City of Columbia

Re: Supplemental Information for Public Hearing - Stadium and Old 63 Intersection Improvements

Subject: Pedestrian Crossing at Stadium Boulevard and Old 63 J5S3092

STADIUM BLVD. AT OLD 63 INTERSECTION IMPROVEMENTS PLAN SHEET (PL-1)

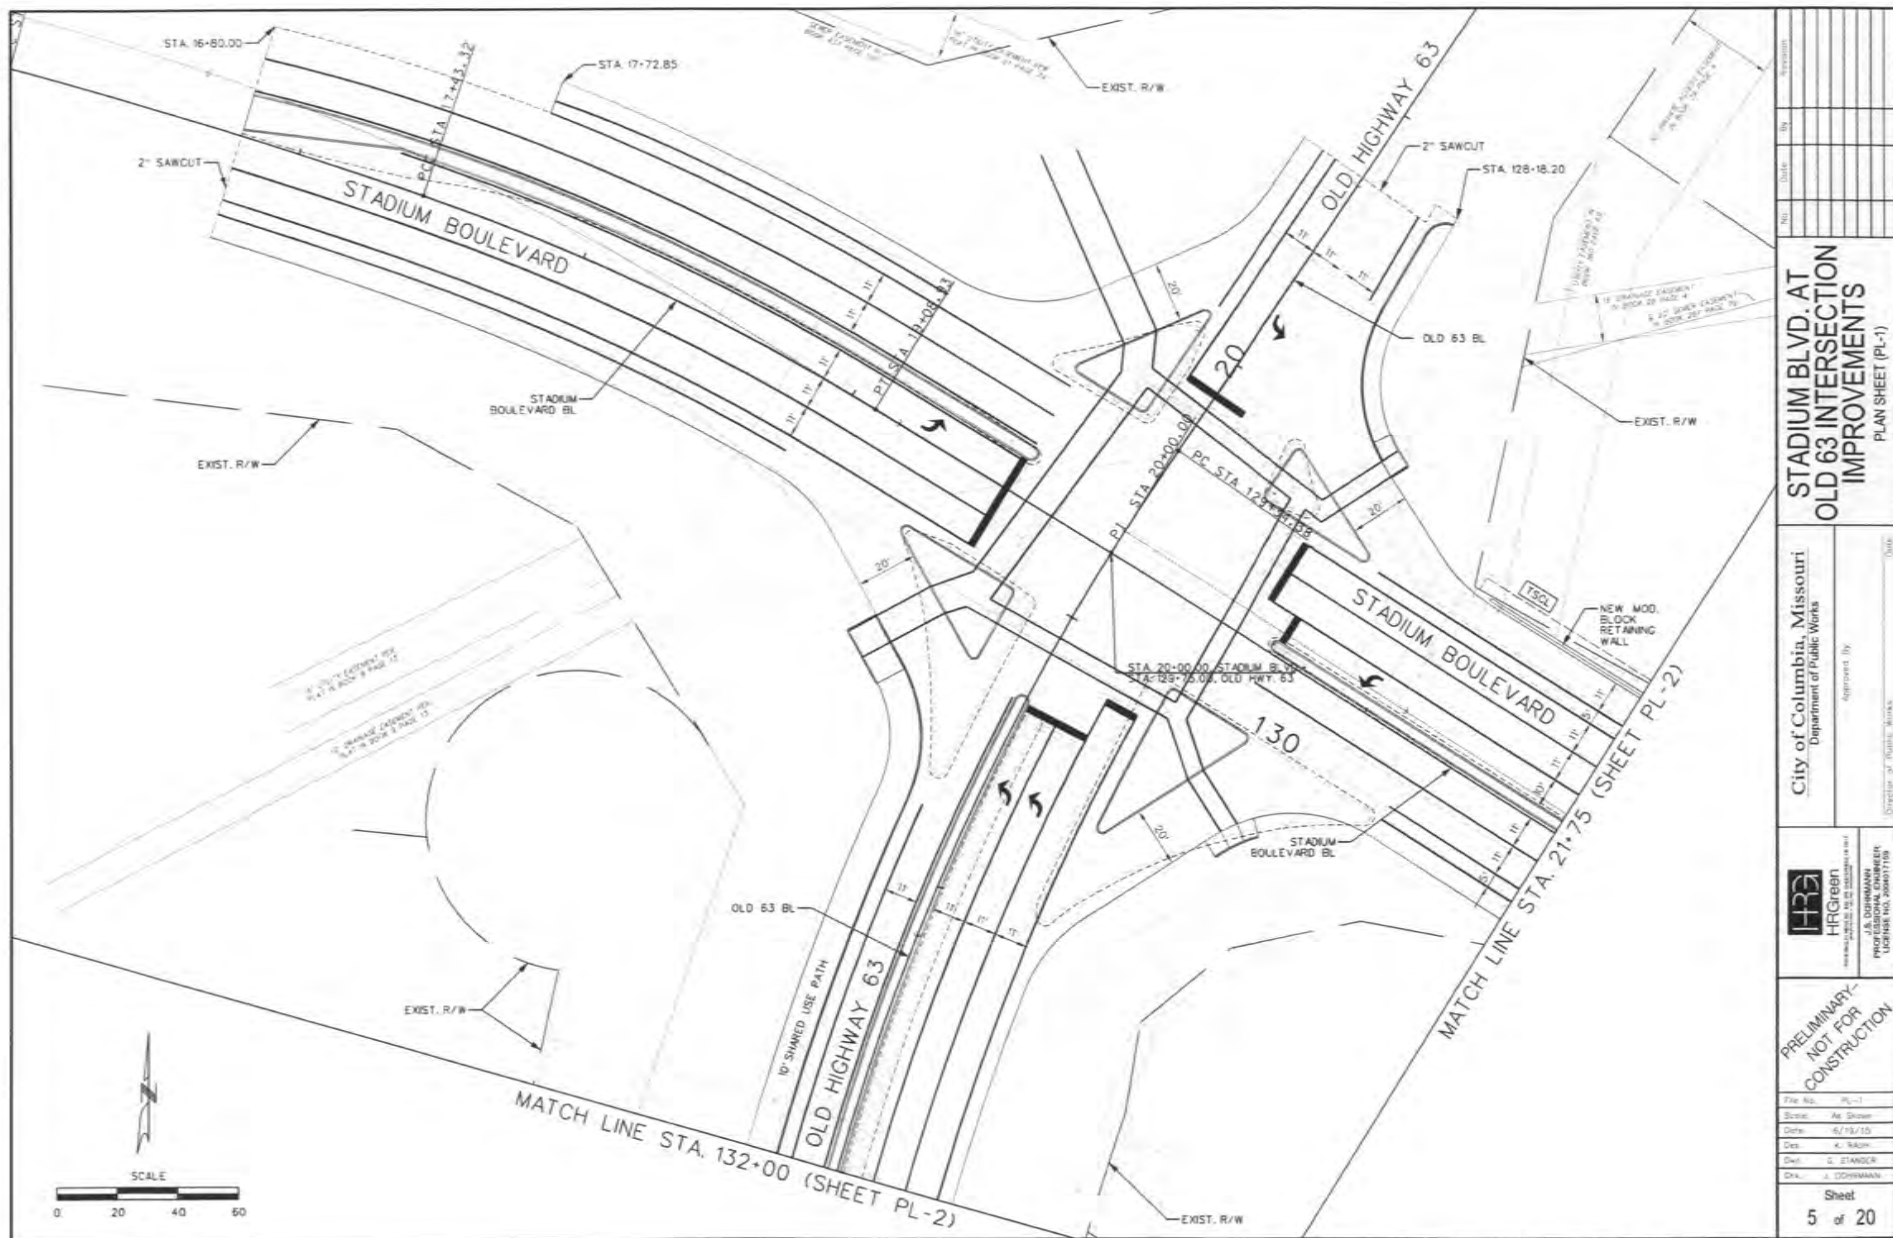
This letter is intended to clarify the pedestrian improvements at Route 740 and Old 63. The scope of the project included ADA compliant crosswalks being installed at the west and north legs of the intersection along with pedestrian signals, pedestrian havens and pushbuttons in three channelizing islands and pavement markings.

MoDOT does not typically construct pedestrian crossings at locations where receiving pedestrian facilities do not exist. At the request of the City of Columbia, MoDOT will allow ADA compliant crosswalks at the south and east legs of the intersection along with the pedestrian signal, pedestrian haven, and pushbutton at the remaining channelizing island as long as accommodations are provided to get pedestrians completely off the roadway. MoDOT is allowing the additional crosswalks to facilitate the future addition of sidewalks on the east side of Old 63 from the intersection south to the park. This additional scope will be at the City's expense.

There has been discussion that the addition of the northbound left turn lane to westbound Stadium is not warranted. MoDOT believes this improvement is a necessity that must be constructed with this project as agreed upon in the cost apportionment agreement.

STADIUM AND OLD 63 NORTHBOUND LEFT TURNS

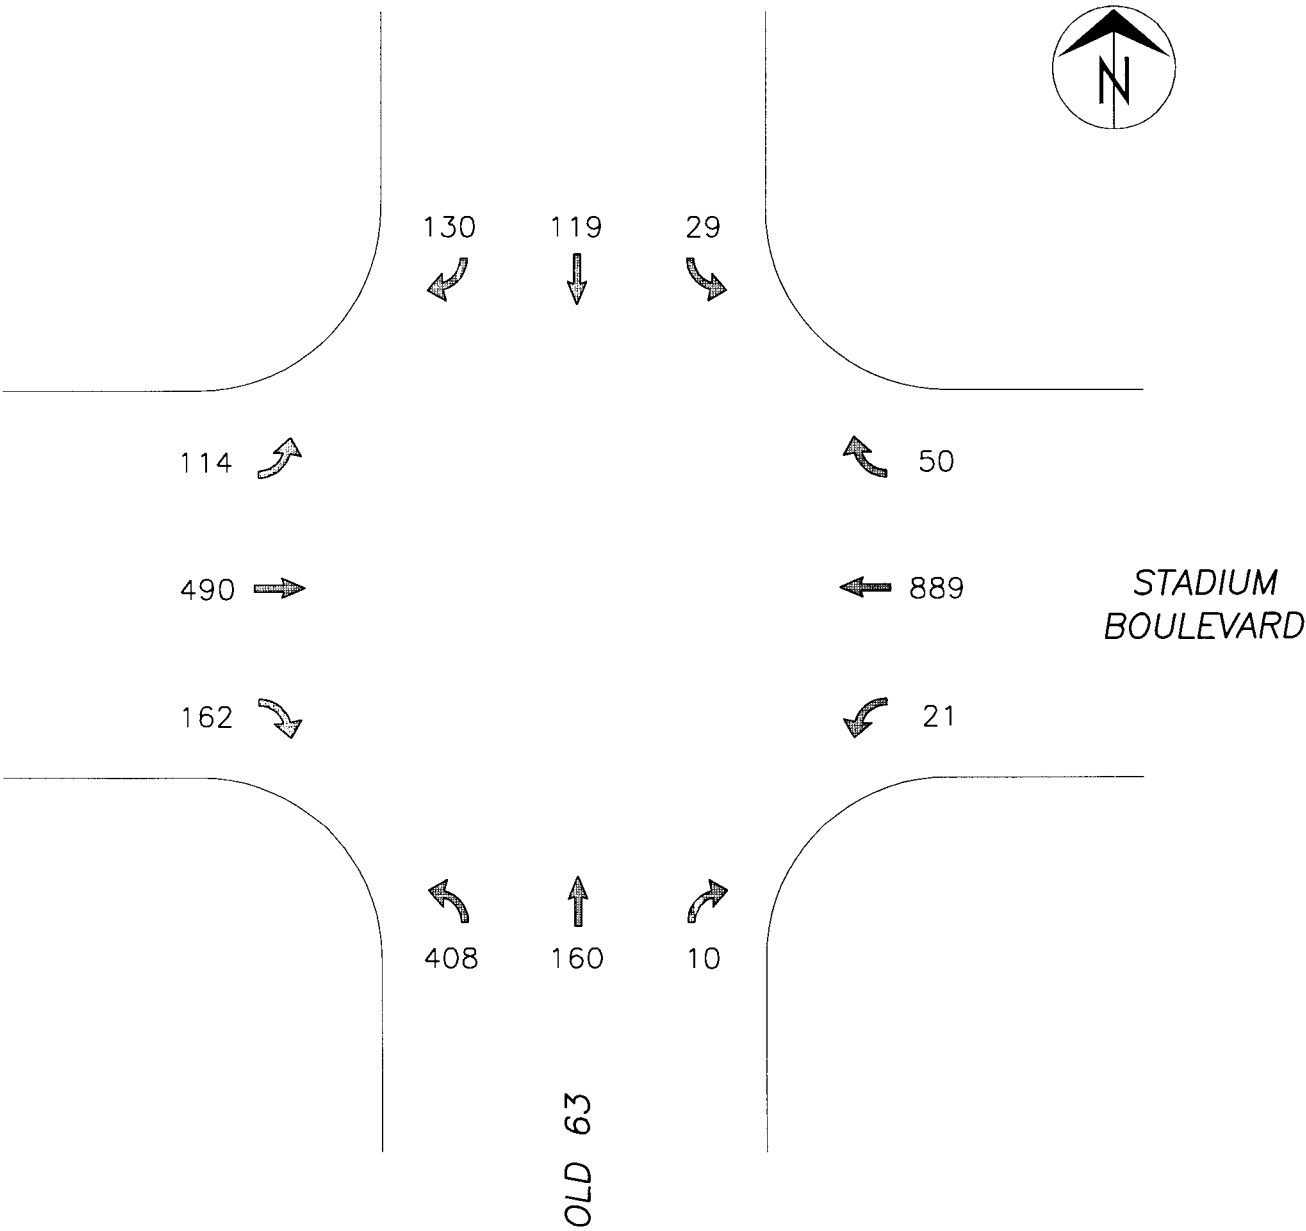
The results from the simulation show that the existing intersection is operating during peak hour with an average delay per vehicle of 45 seconds, or LOS D. The northbound left turn movement is operating during peak hour with an average delay per vehicle of 139 seconds, or LOS F.

When the simulation was run with dual left turns for the northbound approach, the average delay for the intersection during peak hour was 28 seconds, or LOS C, and the average delay for the northbound left turn movement during peak hour was 55 seconds, or LOS D.

Earlier in the year, the Columbia Police Department contacted Public Works staff concerning traffic related issues at the Stadium and Old Hwy 63 intersection. In order to avoid the long delay for the northbound left turning movement, drivers are finding other ways to get through the intersection. In Example #1, of the attached diagram, cars are traveling north on Old Hwy 63, crossing Stadium and then conducting a U-turn at or near the entrance to Break Time to turn west on Stadium from Old Hwy 63. In Example #2, cars are traveling north on Old Hwy 63, crossing Stadium and then entering the lot of Break Time, turning left into the lot of McGinty's, then exiting the lot and traveling south on Old Hwy 63 to turn west on Stadium.

Both of these maneuvers were observed repeatedly by staff during the traffic count performed on May 6, 2015 and, along with running red lights, are the types of maneuvers that are to be expected when a movement through an intersection has reached LOS F. Adding a second northbound left turn lane will lengthen the crosswalk on the south leg of the intersection; however, improving vehicular capacity should provide greater safety for pedestrians because the reduced delay time for vehicles should remove the desire by drivers to perform risky maneuvers at the intersection.
